Access Compliance Report Public Rights-of-Way (Curb Ramps)

Intersection ID: N/A Main Street: CALVET_CT Cross Street: BEAUCLAIRE_LN Location: NW

ADA ID: 4C3B4F4F79A2 Ramp Type: Perp Initial Pass/Fail: Fail Overall Compliance: No Severity Score: 12.5

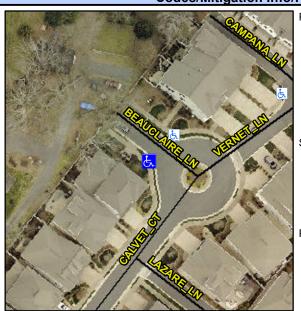
PROW/ADA:

R304.5.3

Field Measurements/Component Compliance					
Compliance Description		Data	Comp	liance Description	Data
N/A	Ramp Length (in)	46.0	Yes	Ramp Slope (%)	5.5
Yes	Ramp Width (in)	48.0	No	Ramp XSlope (%)	6.4
N/A	Flare Type LT	N/A	N/A	Flare Type RT	N/A
N/A	Flare Slope LT (%)	N/A	N/A	Flare Slope RT (%)	N/A
N/A	Flare Traversable LT?	N/A	N/A	Flare Traversable RT?	N/A
N/A	Landing Length (in)	N/A	N/A	DWS Provided?	N/A
N/A	Landing Width (in)	N/A	N/A	DWS Contrast?	N/A
N/A	Landing Slope (%)	N/A	N/A	DWS Length (in)	N/A
N/A	Landing X Slope (%)	N/A	N/A	DWS Full Width?	N/A
N/A	Landing Curb? (Y/N)	N/A	N/A	DWS Offset (in)	N/A
N/A	Shared Landing?	N/A			
N/A	Gutter Ponding?	N/A	N/A	Gutter Slope (%)	N/A
N/A	Gutter Lip Ht (in)	N/A	N/A	Gutter X Slope (%)	N/A
N/A	Painted X Walk1?	No	N/A	Painted X Walk2?	N/A
	X Walk 1 Direction	To NE		X Walk 2 Direction	N/A
N/A	X Walk 1 Width (in)	N/A	N/A	X Walk 2 Width (in)	N/A
	X Walk 1 Slope (%)	0.9		X Walk 2 Slope (%)	N/A

Remove & Replace Entire Ramp.
